CITY OF HARTFORD
DEPARTMENT OF ENGINEERING

**SOUTH MEADOWS
PUMPING STATION**

DETAILS OF OUTLET STRUCTURE

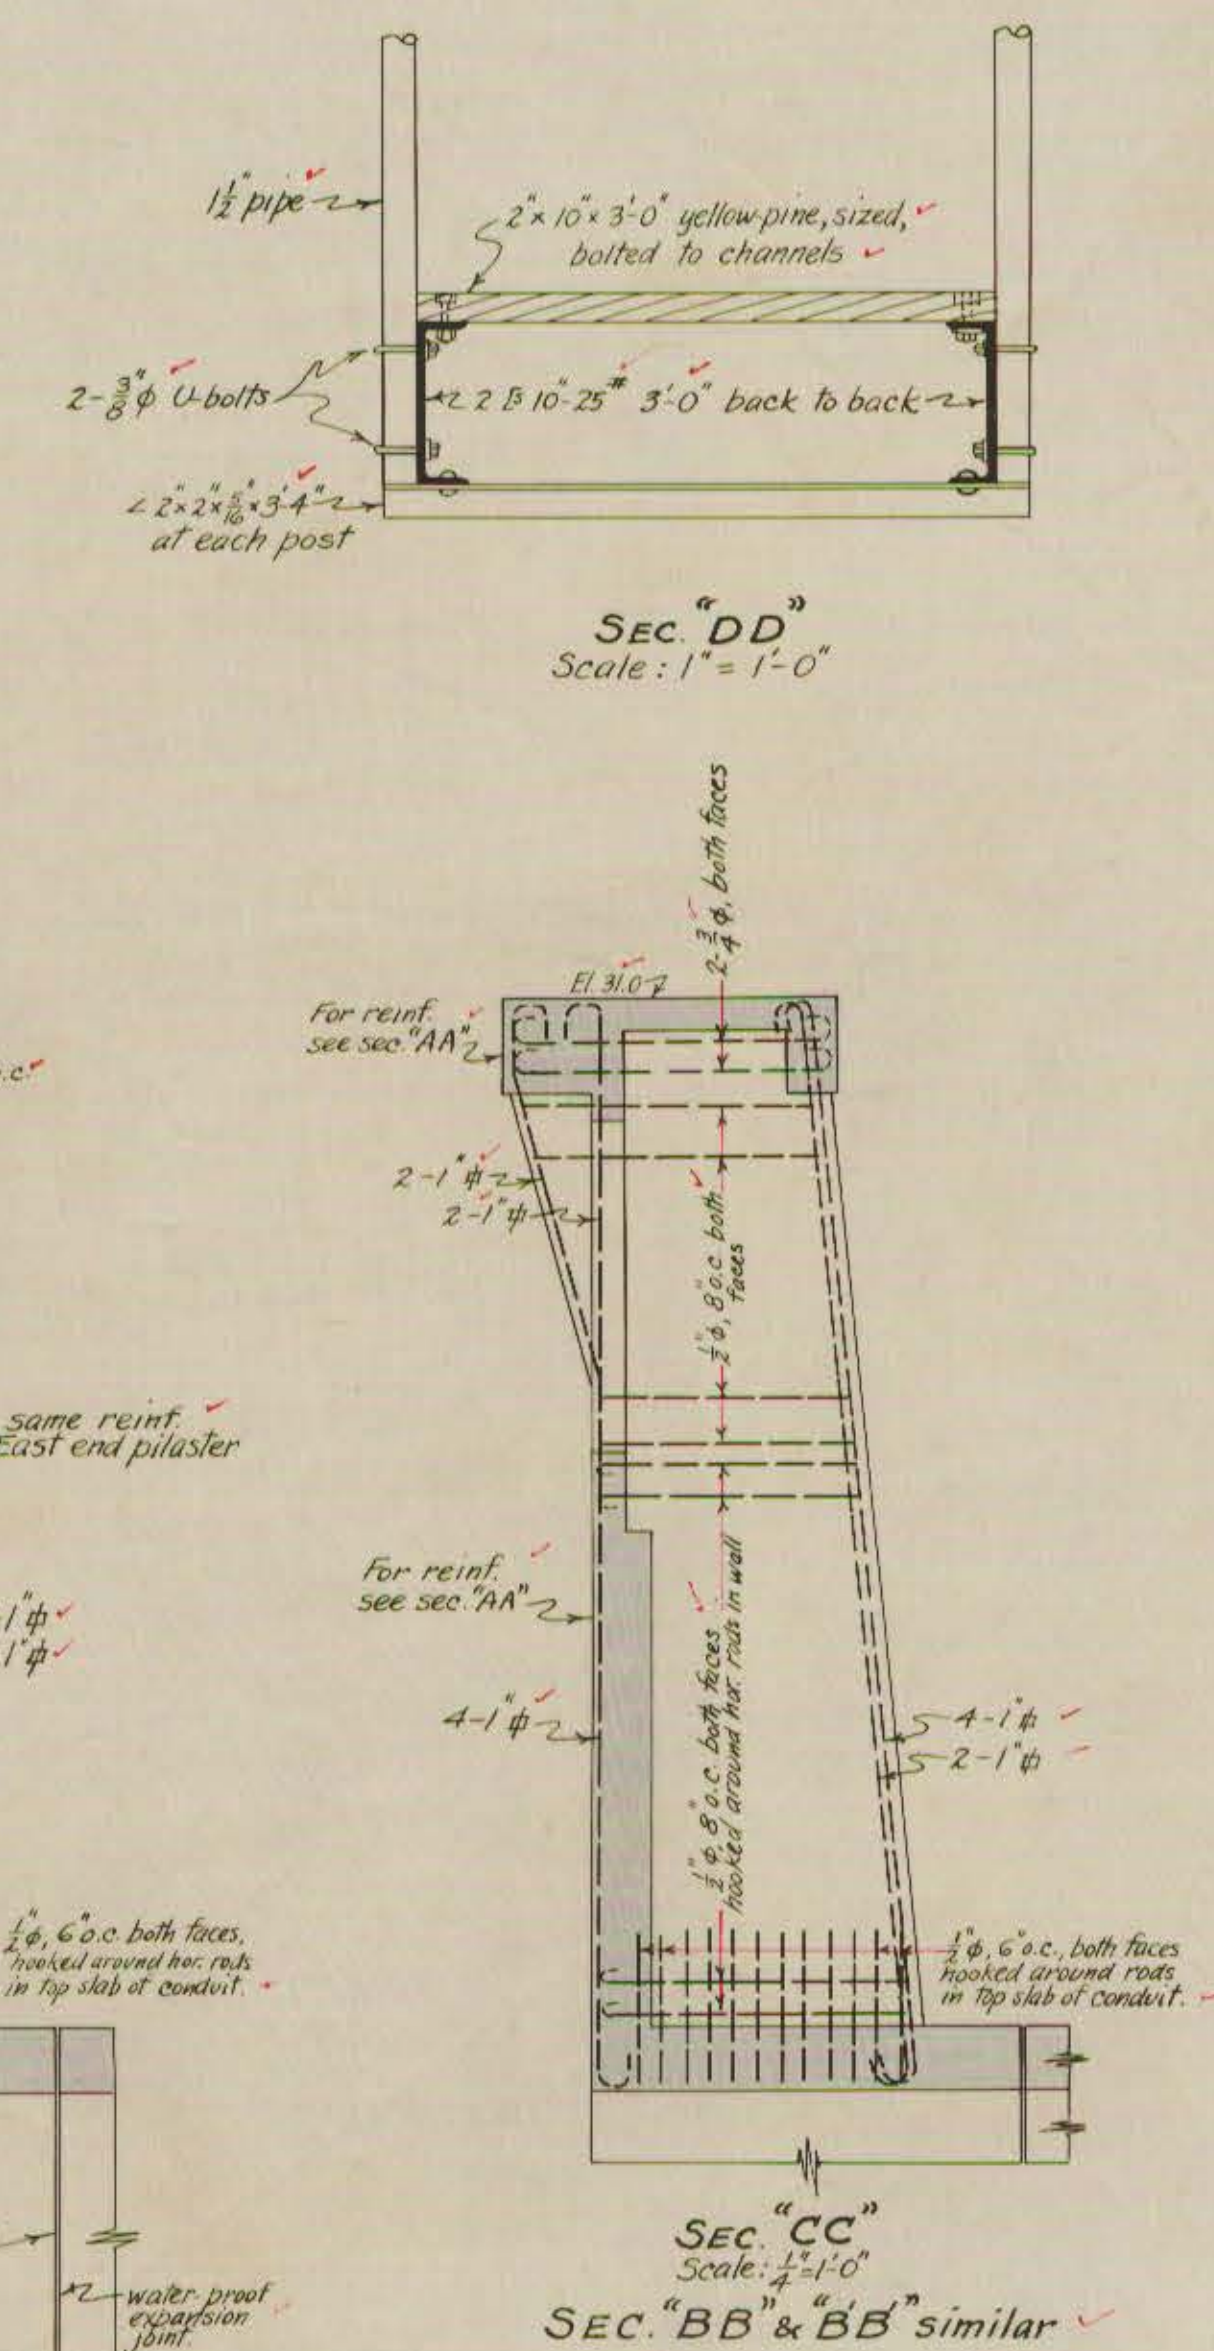
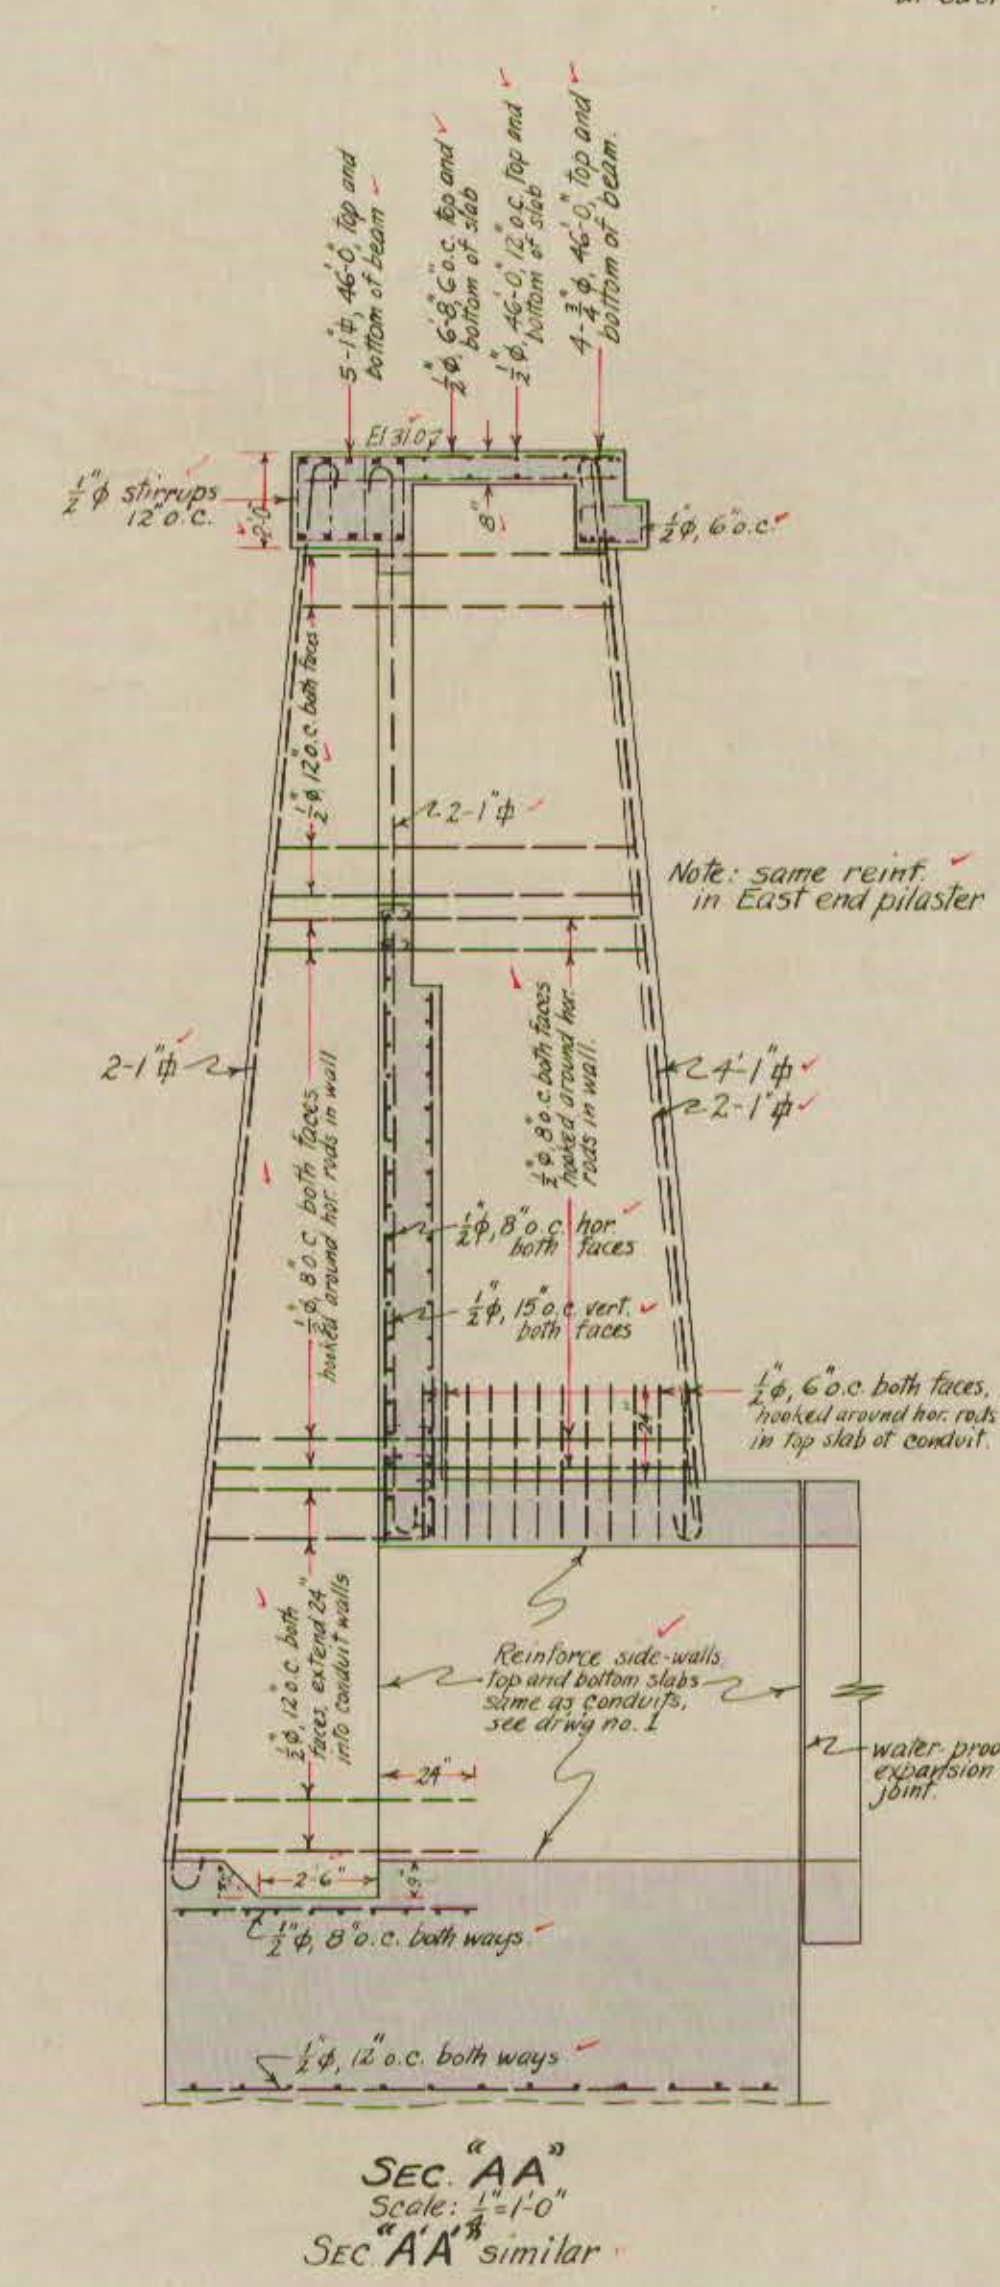
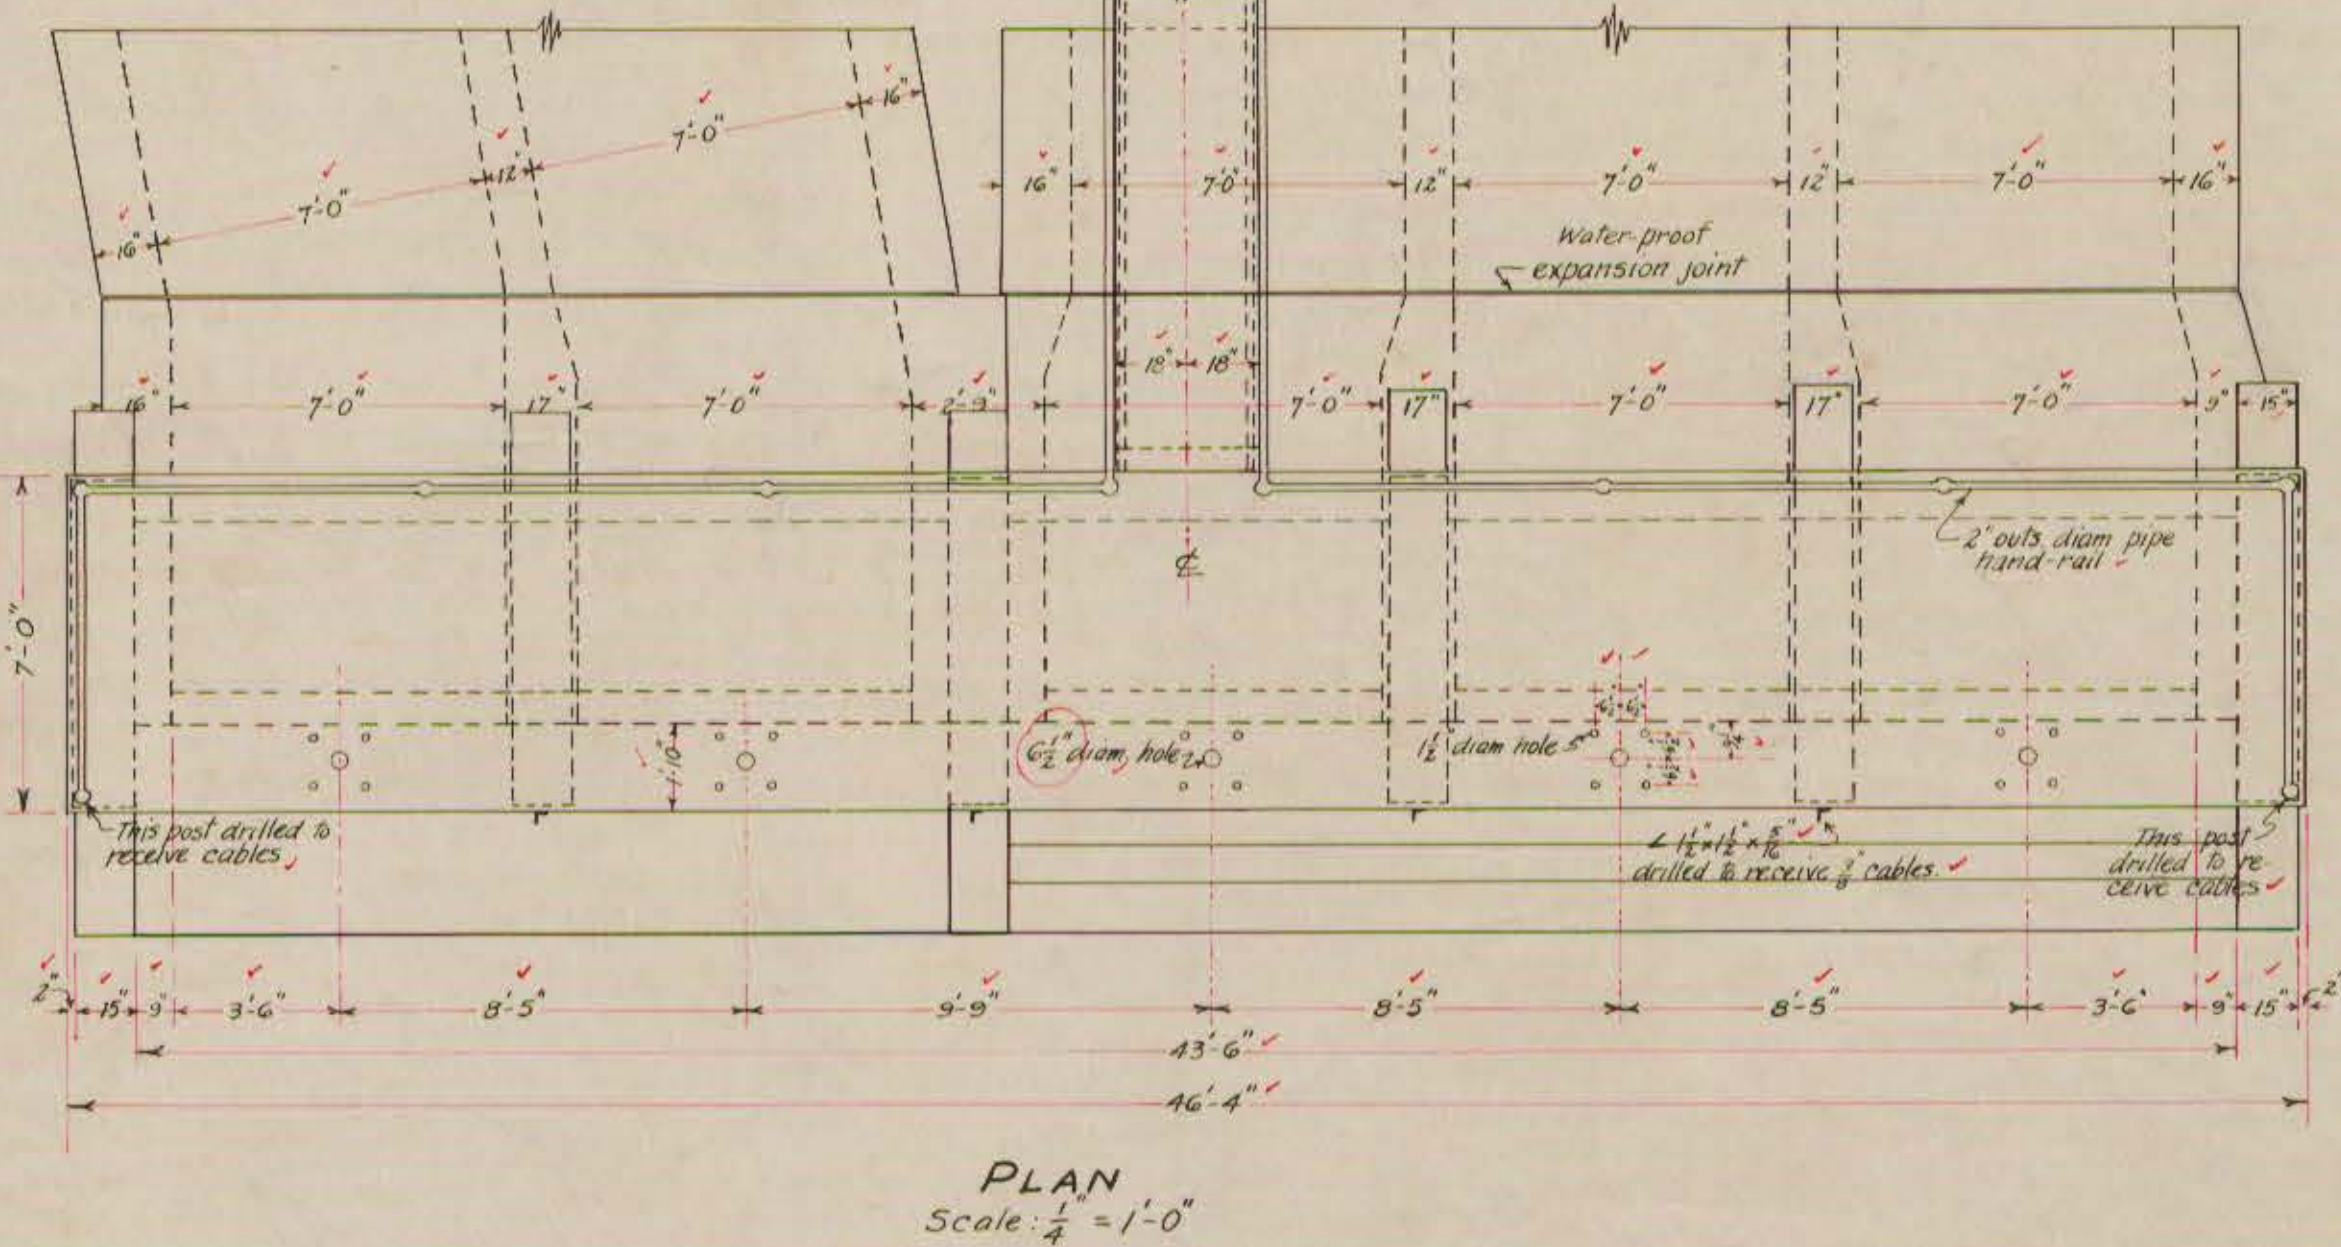
DATE	REVISION	BY	APPROVED BY
7-22-31	East Elevation, added 5 dimensions and changed slope of N. pilasters.	N.S.F.	M.D.
8-19-34	Plan, changed holes for stems, from 4" diam. to 6 $\frac{1}{2}$ "	N.S.F.	M.D.
